# RETREAT AT TIMBERRIDGE FILING NO. 3

# UTILITY CONSTRUCTION DRAWINGS

### DECEMBER 2022

**RETREAT AT TIMBERIDGE FILING NO. 3**  
CONSTRUCTION PLANS  
UTILITY SERVICE PLAN

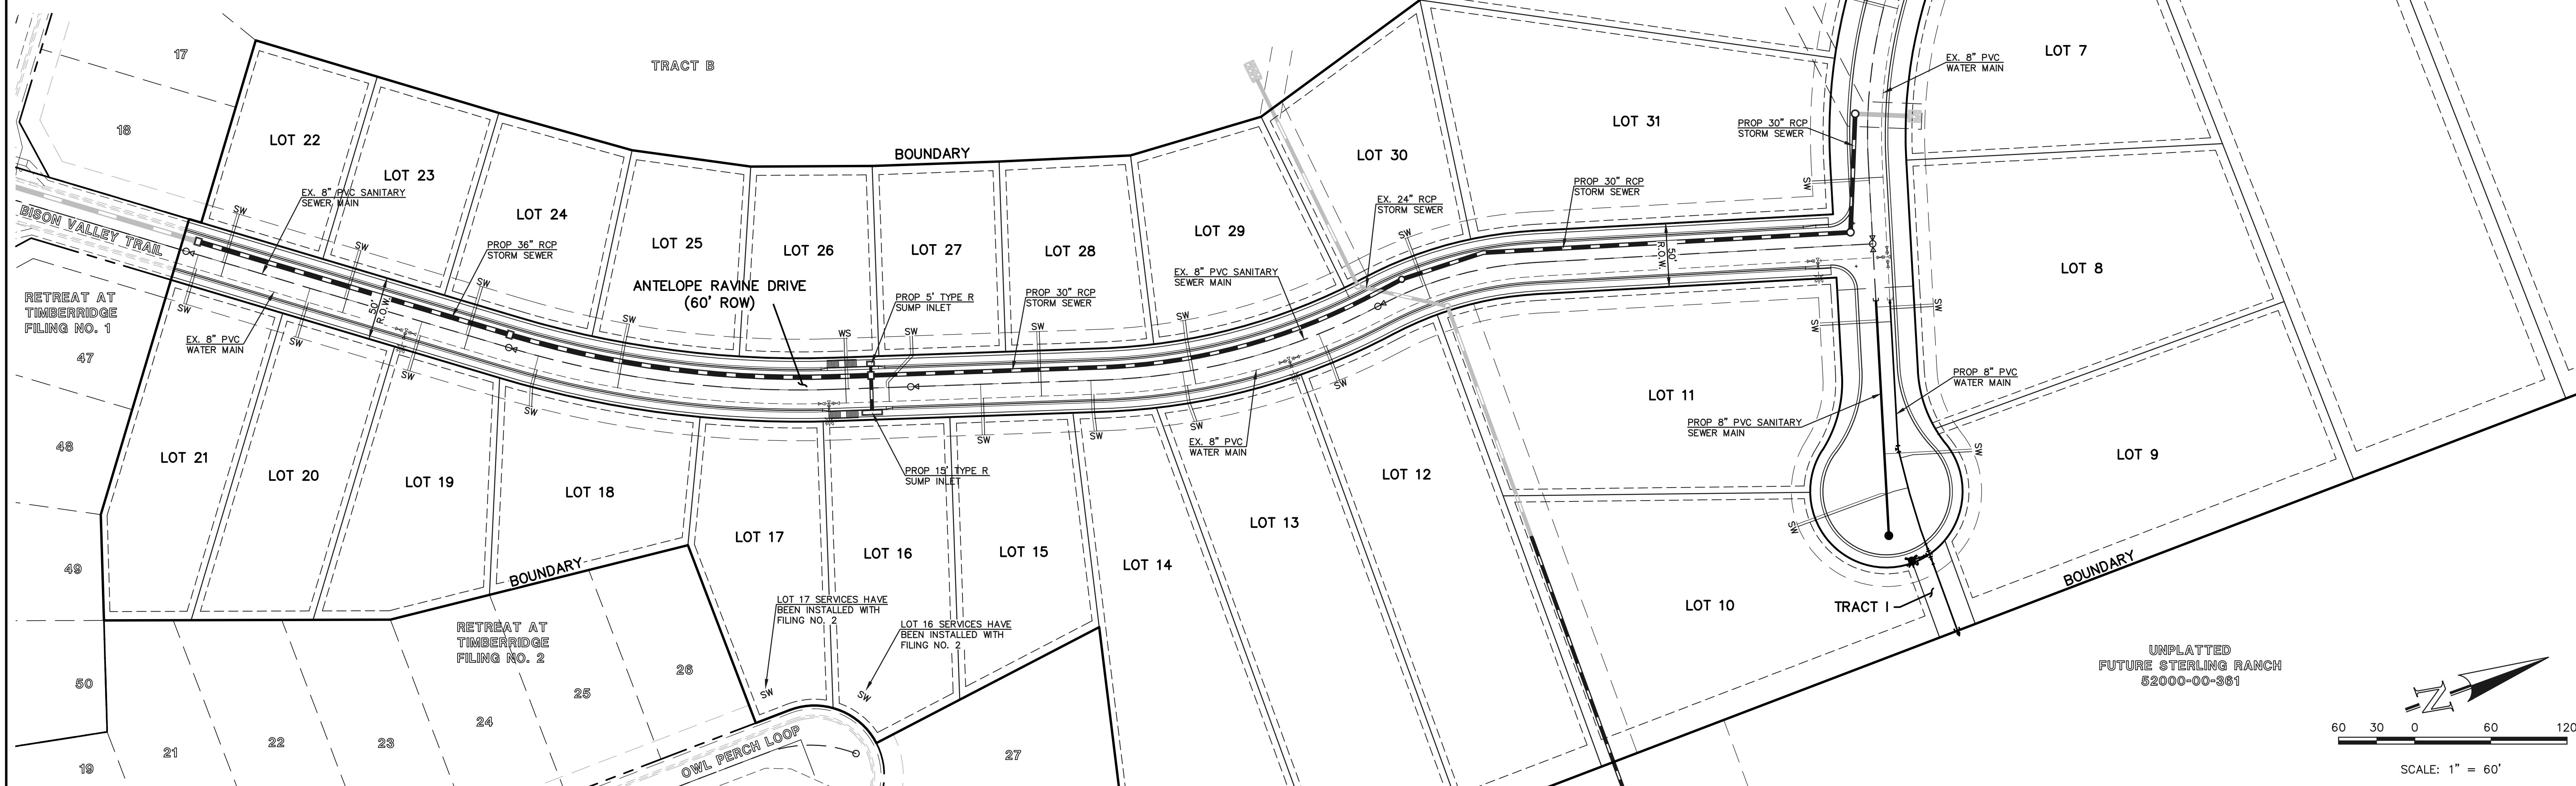
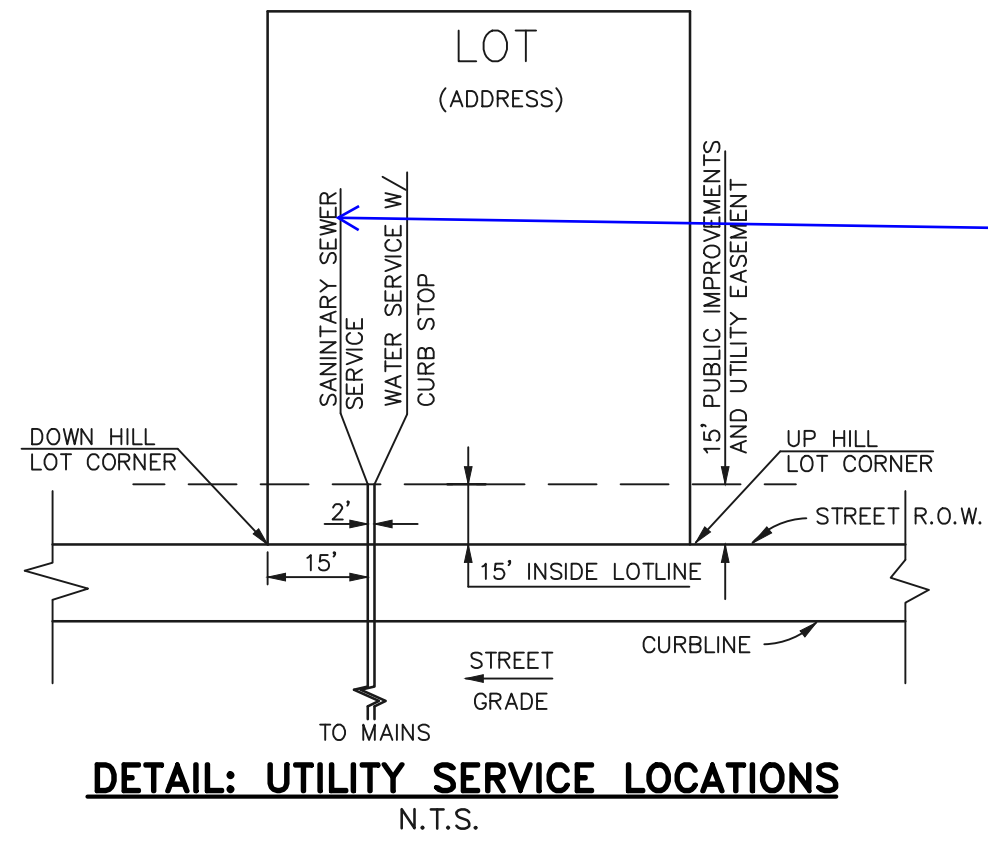
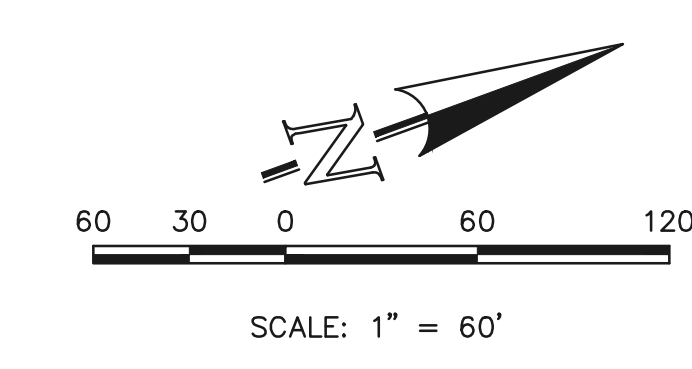
Address underdrains if proposed per plat notes.
